TITLE: WAIVER of Condition #1.1.1 of PRELIMINARY PLAT NO. 04030, JENSEN PARK ESTATES, requested by Engineering Design Consultants on behalf of Jensen Park, LLC, on property generally located at South 84th Street and Yankee Hill Road.

LINCOLN CITY/LANCASTER COUNTY PLANNING STAFF REPORT

- PROJECT #:** Preliminary Plat #04030
- PROPOSAL:** To create 151 single-family residential lots.
- LOCATION:** South 84th Street and Yankee Hill Road.
- WAIVER REQUESTS:**

Preliminary Plat #04030 Jensen Park Estates

JENSEN PARK ESTATES PRELIMINARY PLAT

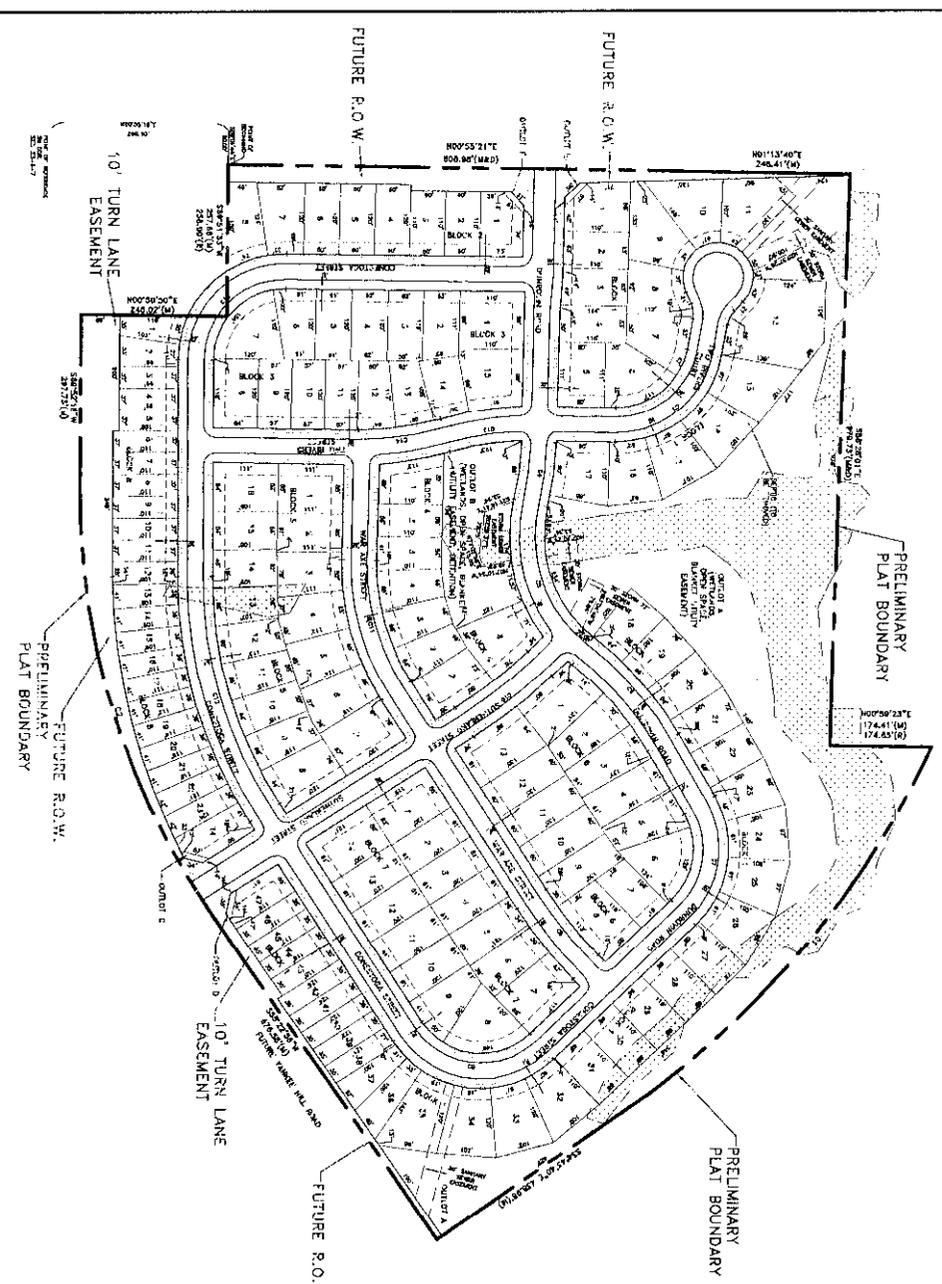
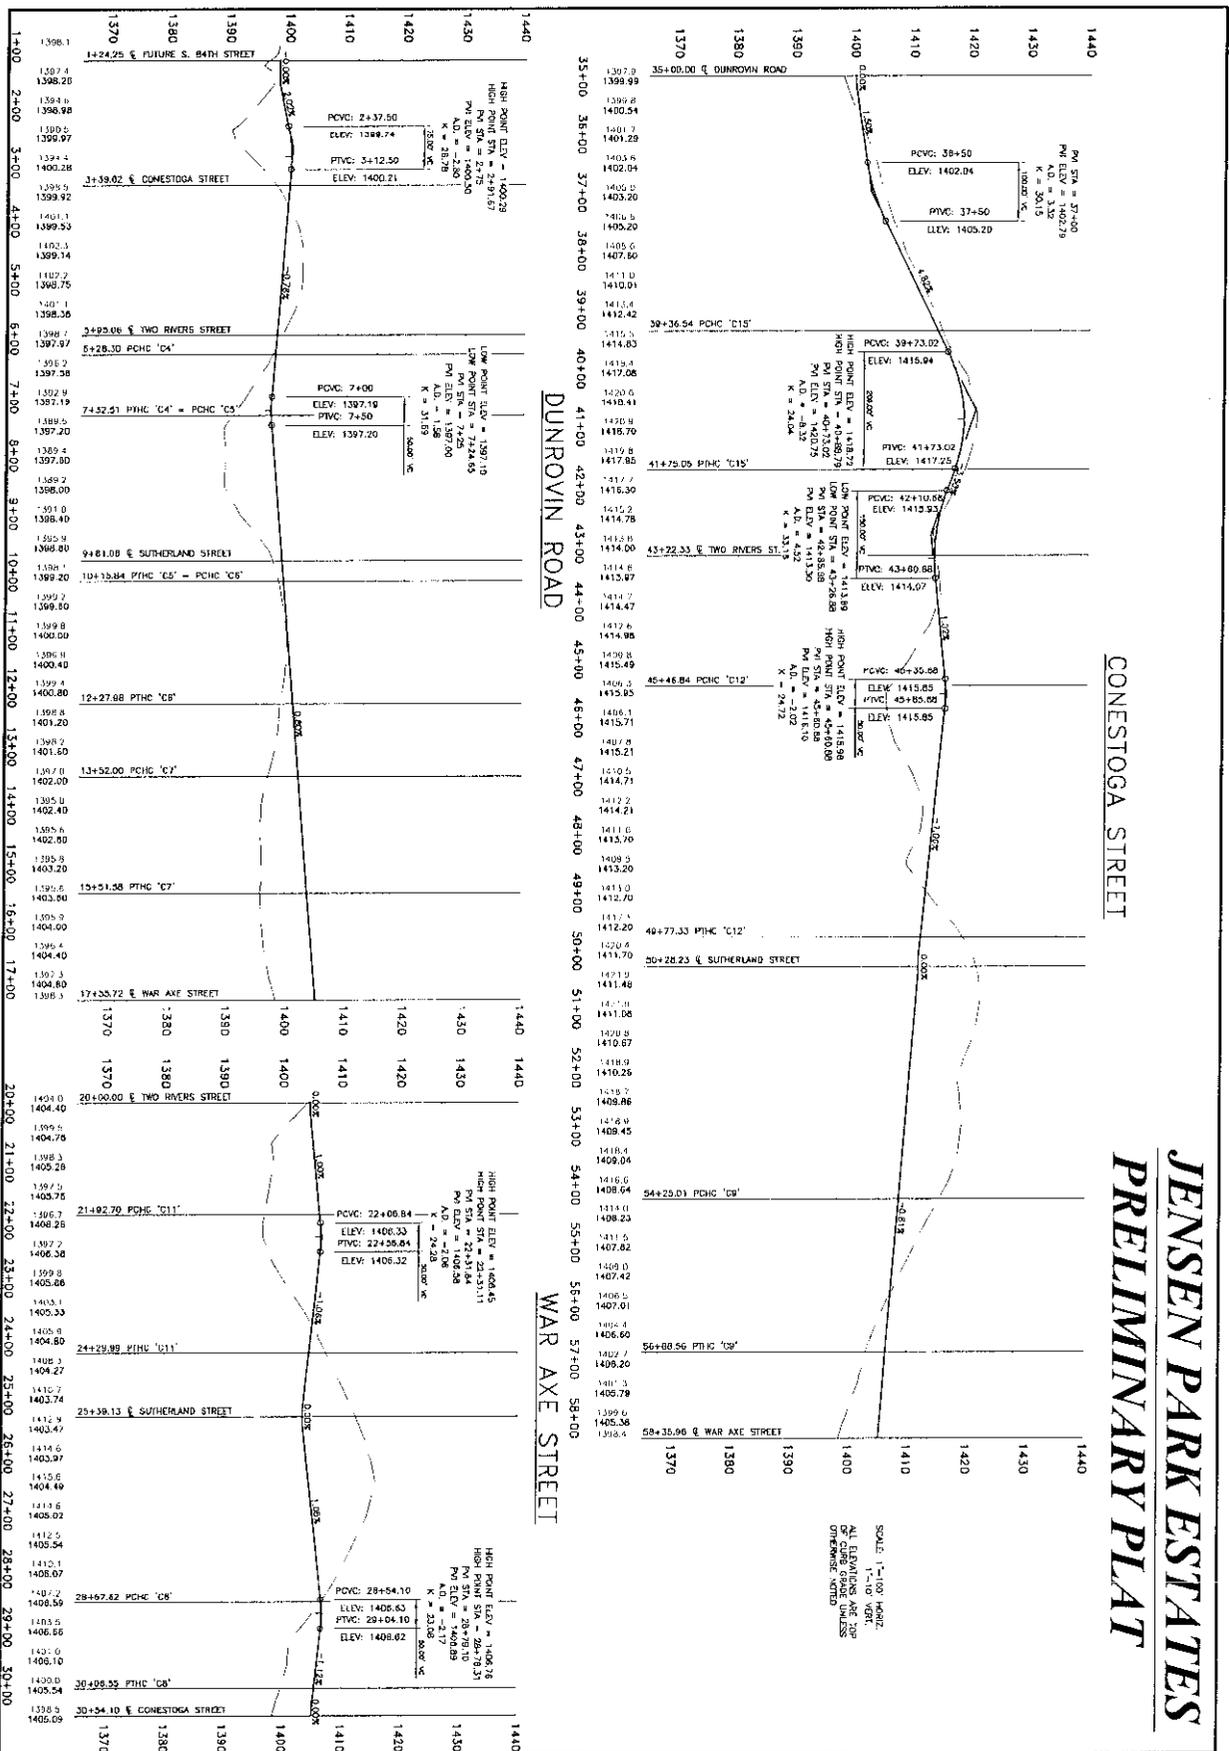
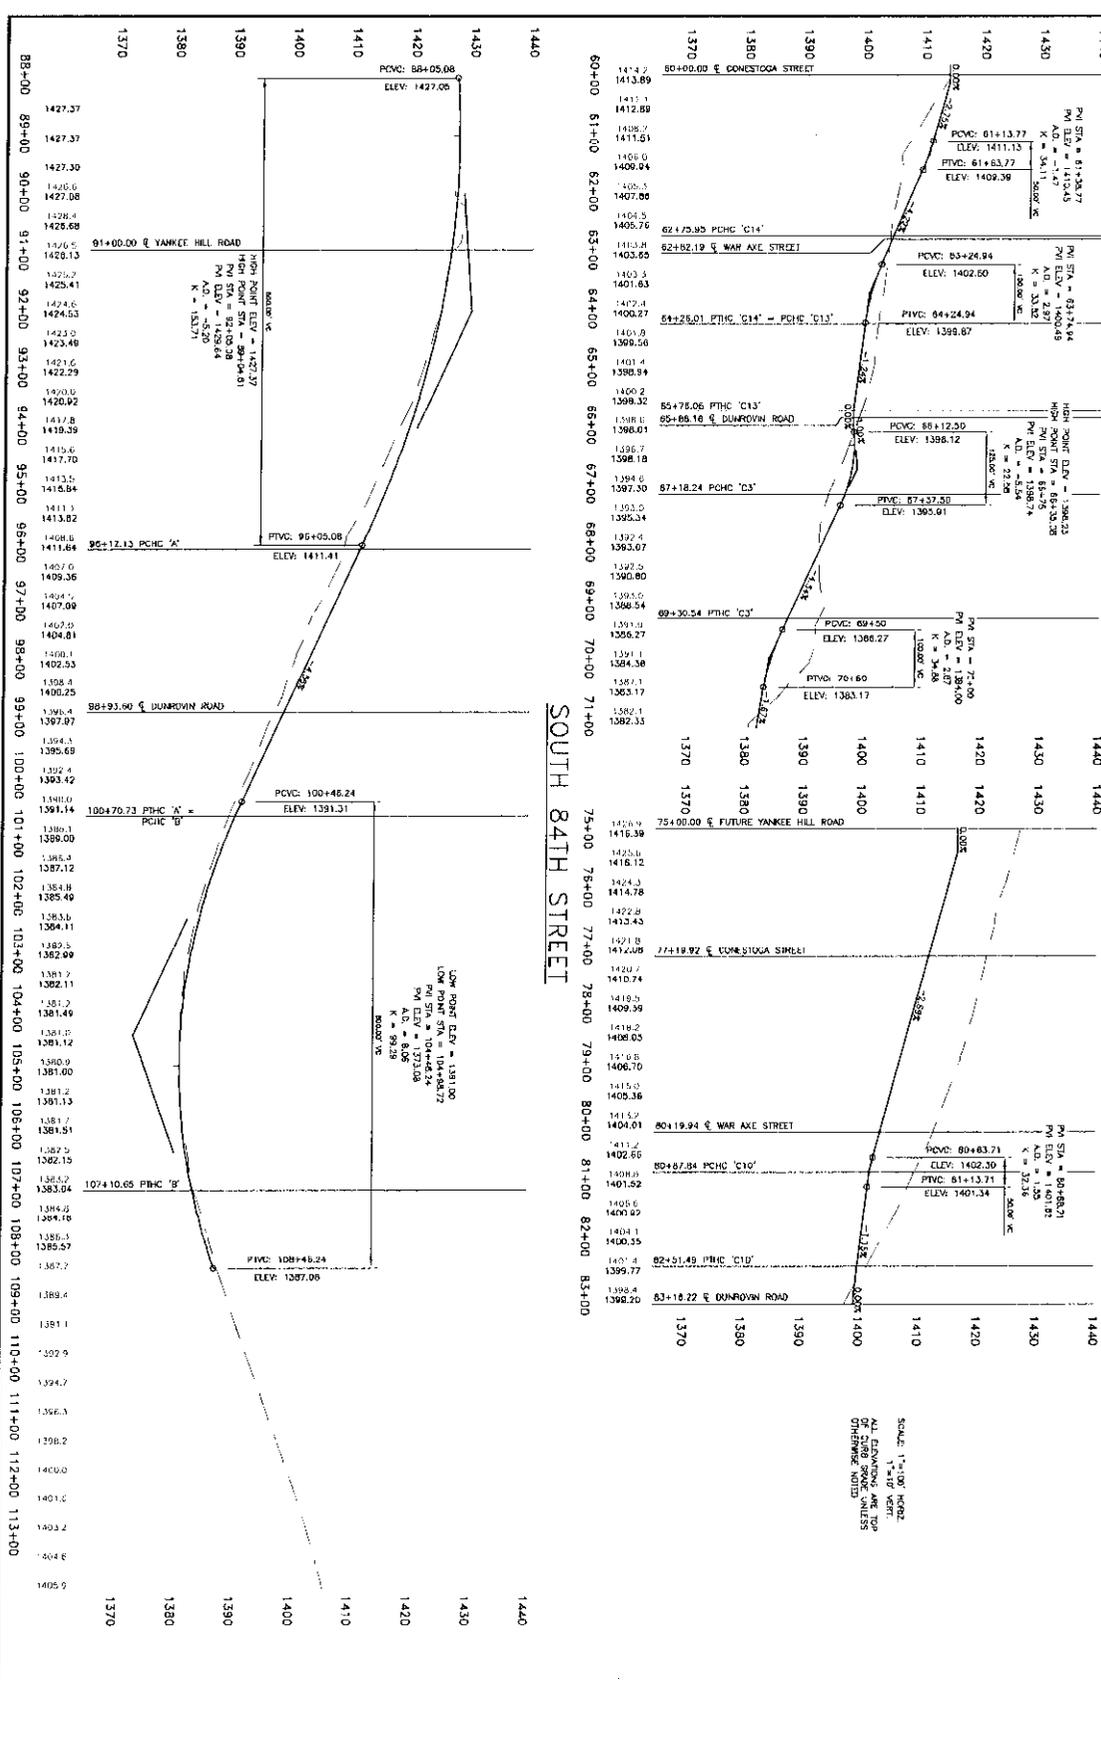
1(3.1) The grading and drainage plan is unsatisfactory. As stated in the previous report, there is a significant area south of Yankee Hill Road that drains to this site via a culvert under Yankee Hill Road. The proposed storm sewer design does not show any storm sewer to connect to this culvert indicating that the storm water from the area to the south will be diverted through the future Yankee Hill storm sewer system to the railroad ditch to the north and east of this plat. This will add additional costs to the Yankee Hill project that would not otherwise be necessary. The grading and drainage plan needs to be revised to show storm sewer available to account for this drainage area. The detention calculations will need to be revised to account for this change.

1(3.2) Although the minimum opening elevations shown for lots in Block 4 are adequate for the 100 year elevation indicated in the detention calculations, the low elevation in the Dunrovin Road cross-section is nearly 1' higher. Since it does not appear that any lots will be affected, the minimum openings for these lots should be revised to match the low point in Dunrovin Road.

1(3.4) The grading for the future 84th Street improvements need to be shown on the grading plan to ensure that the proposed site grading will work with the future roadway grading. Also, design on 84th has not started yet. The 84th Street profile and adjacent grading on this plat may need to be revised when a final profile is set for 84th Street.

(4.1) A street connection needs to be shown extending to Lot 77 to the north of this plat. The submittal letter references the existence of wetlands as justification for not making this connection. Wetland mitigation is taking place in a number of areas throughout the plat and this area would be allowed to be mitigated for. Also, the street connection will provide access to allow Lot 77 to develop in the future and would eliminate the need to create an additional intersection with South 84th Street. Lot 77's proximity to the railroad crossing would be a good location for an intersection.

On behalf of Engineering Design Consultants client, Jensen Park, LLC we hereby resubmit the above referenced Preliminary Plat with the following changes per comment from the Planning Department dated December 10, 2004:

- j. In response to comment 4.2, a street connection will not be shown to the Lot 77 to the north of the plat due to the existing wetlands separating the property.

- b. Title 26, Section 26.23.030 to not project street system into adjacent property. Due to the existing natural feature of wetlands located to the north of the plat, the cost to provide a connection to the north property outweighs the benefit for the developer.
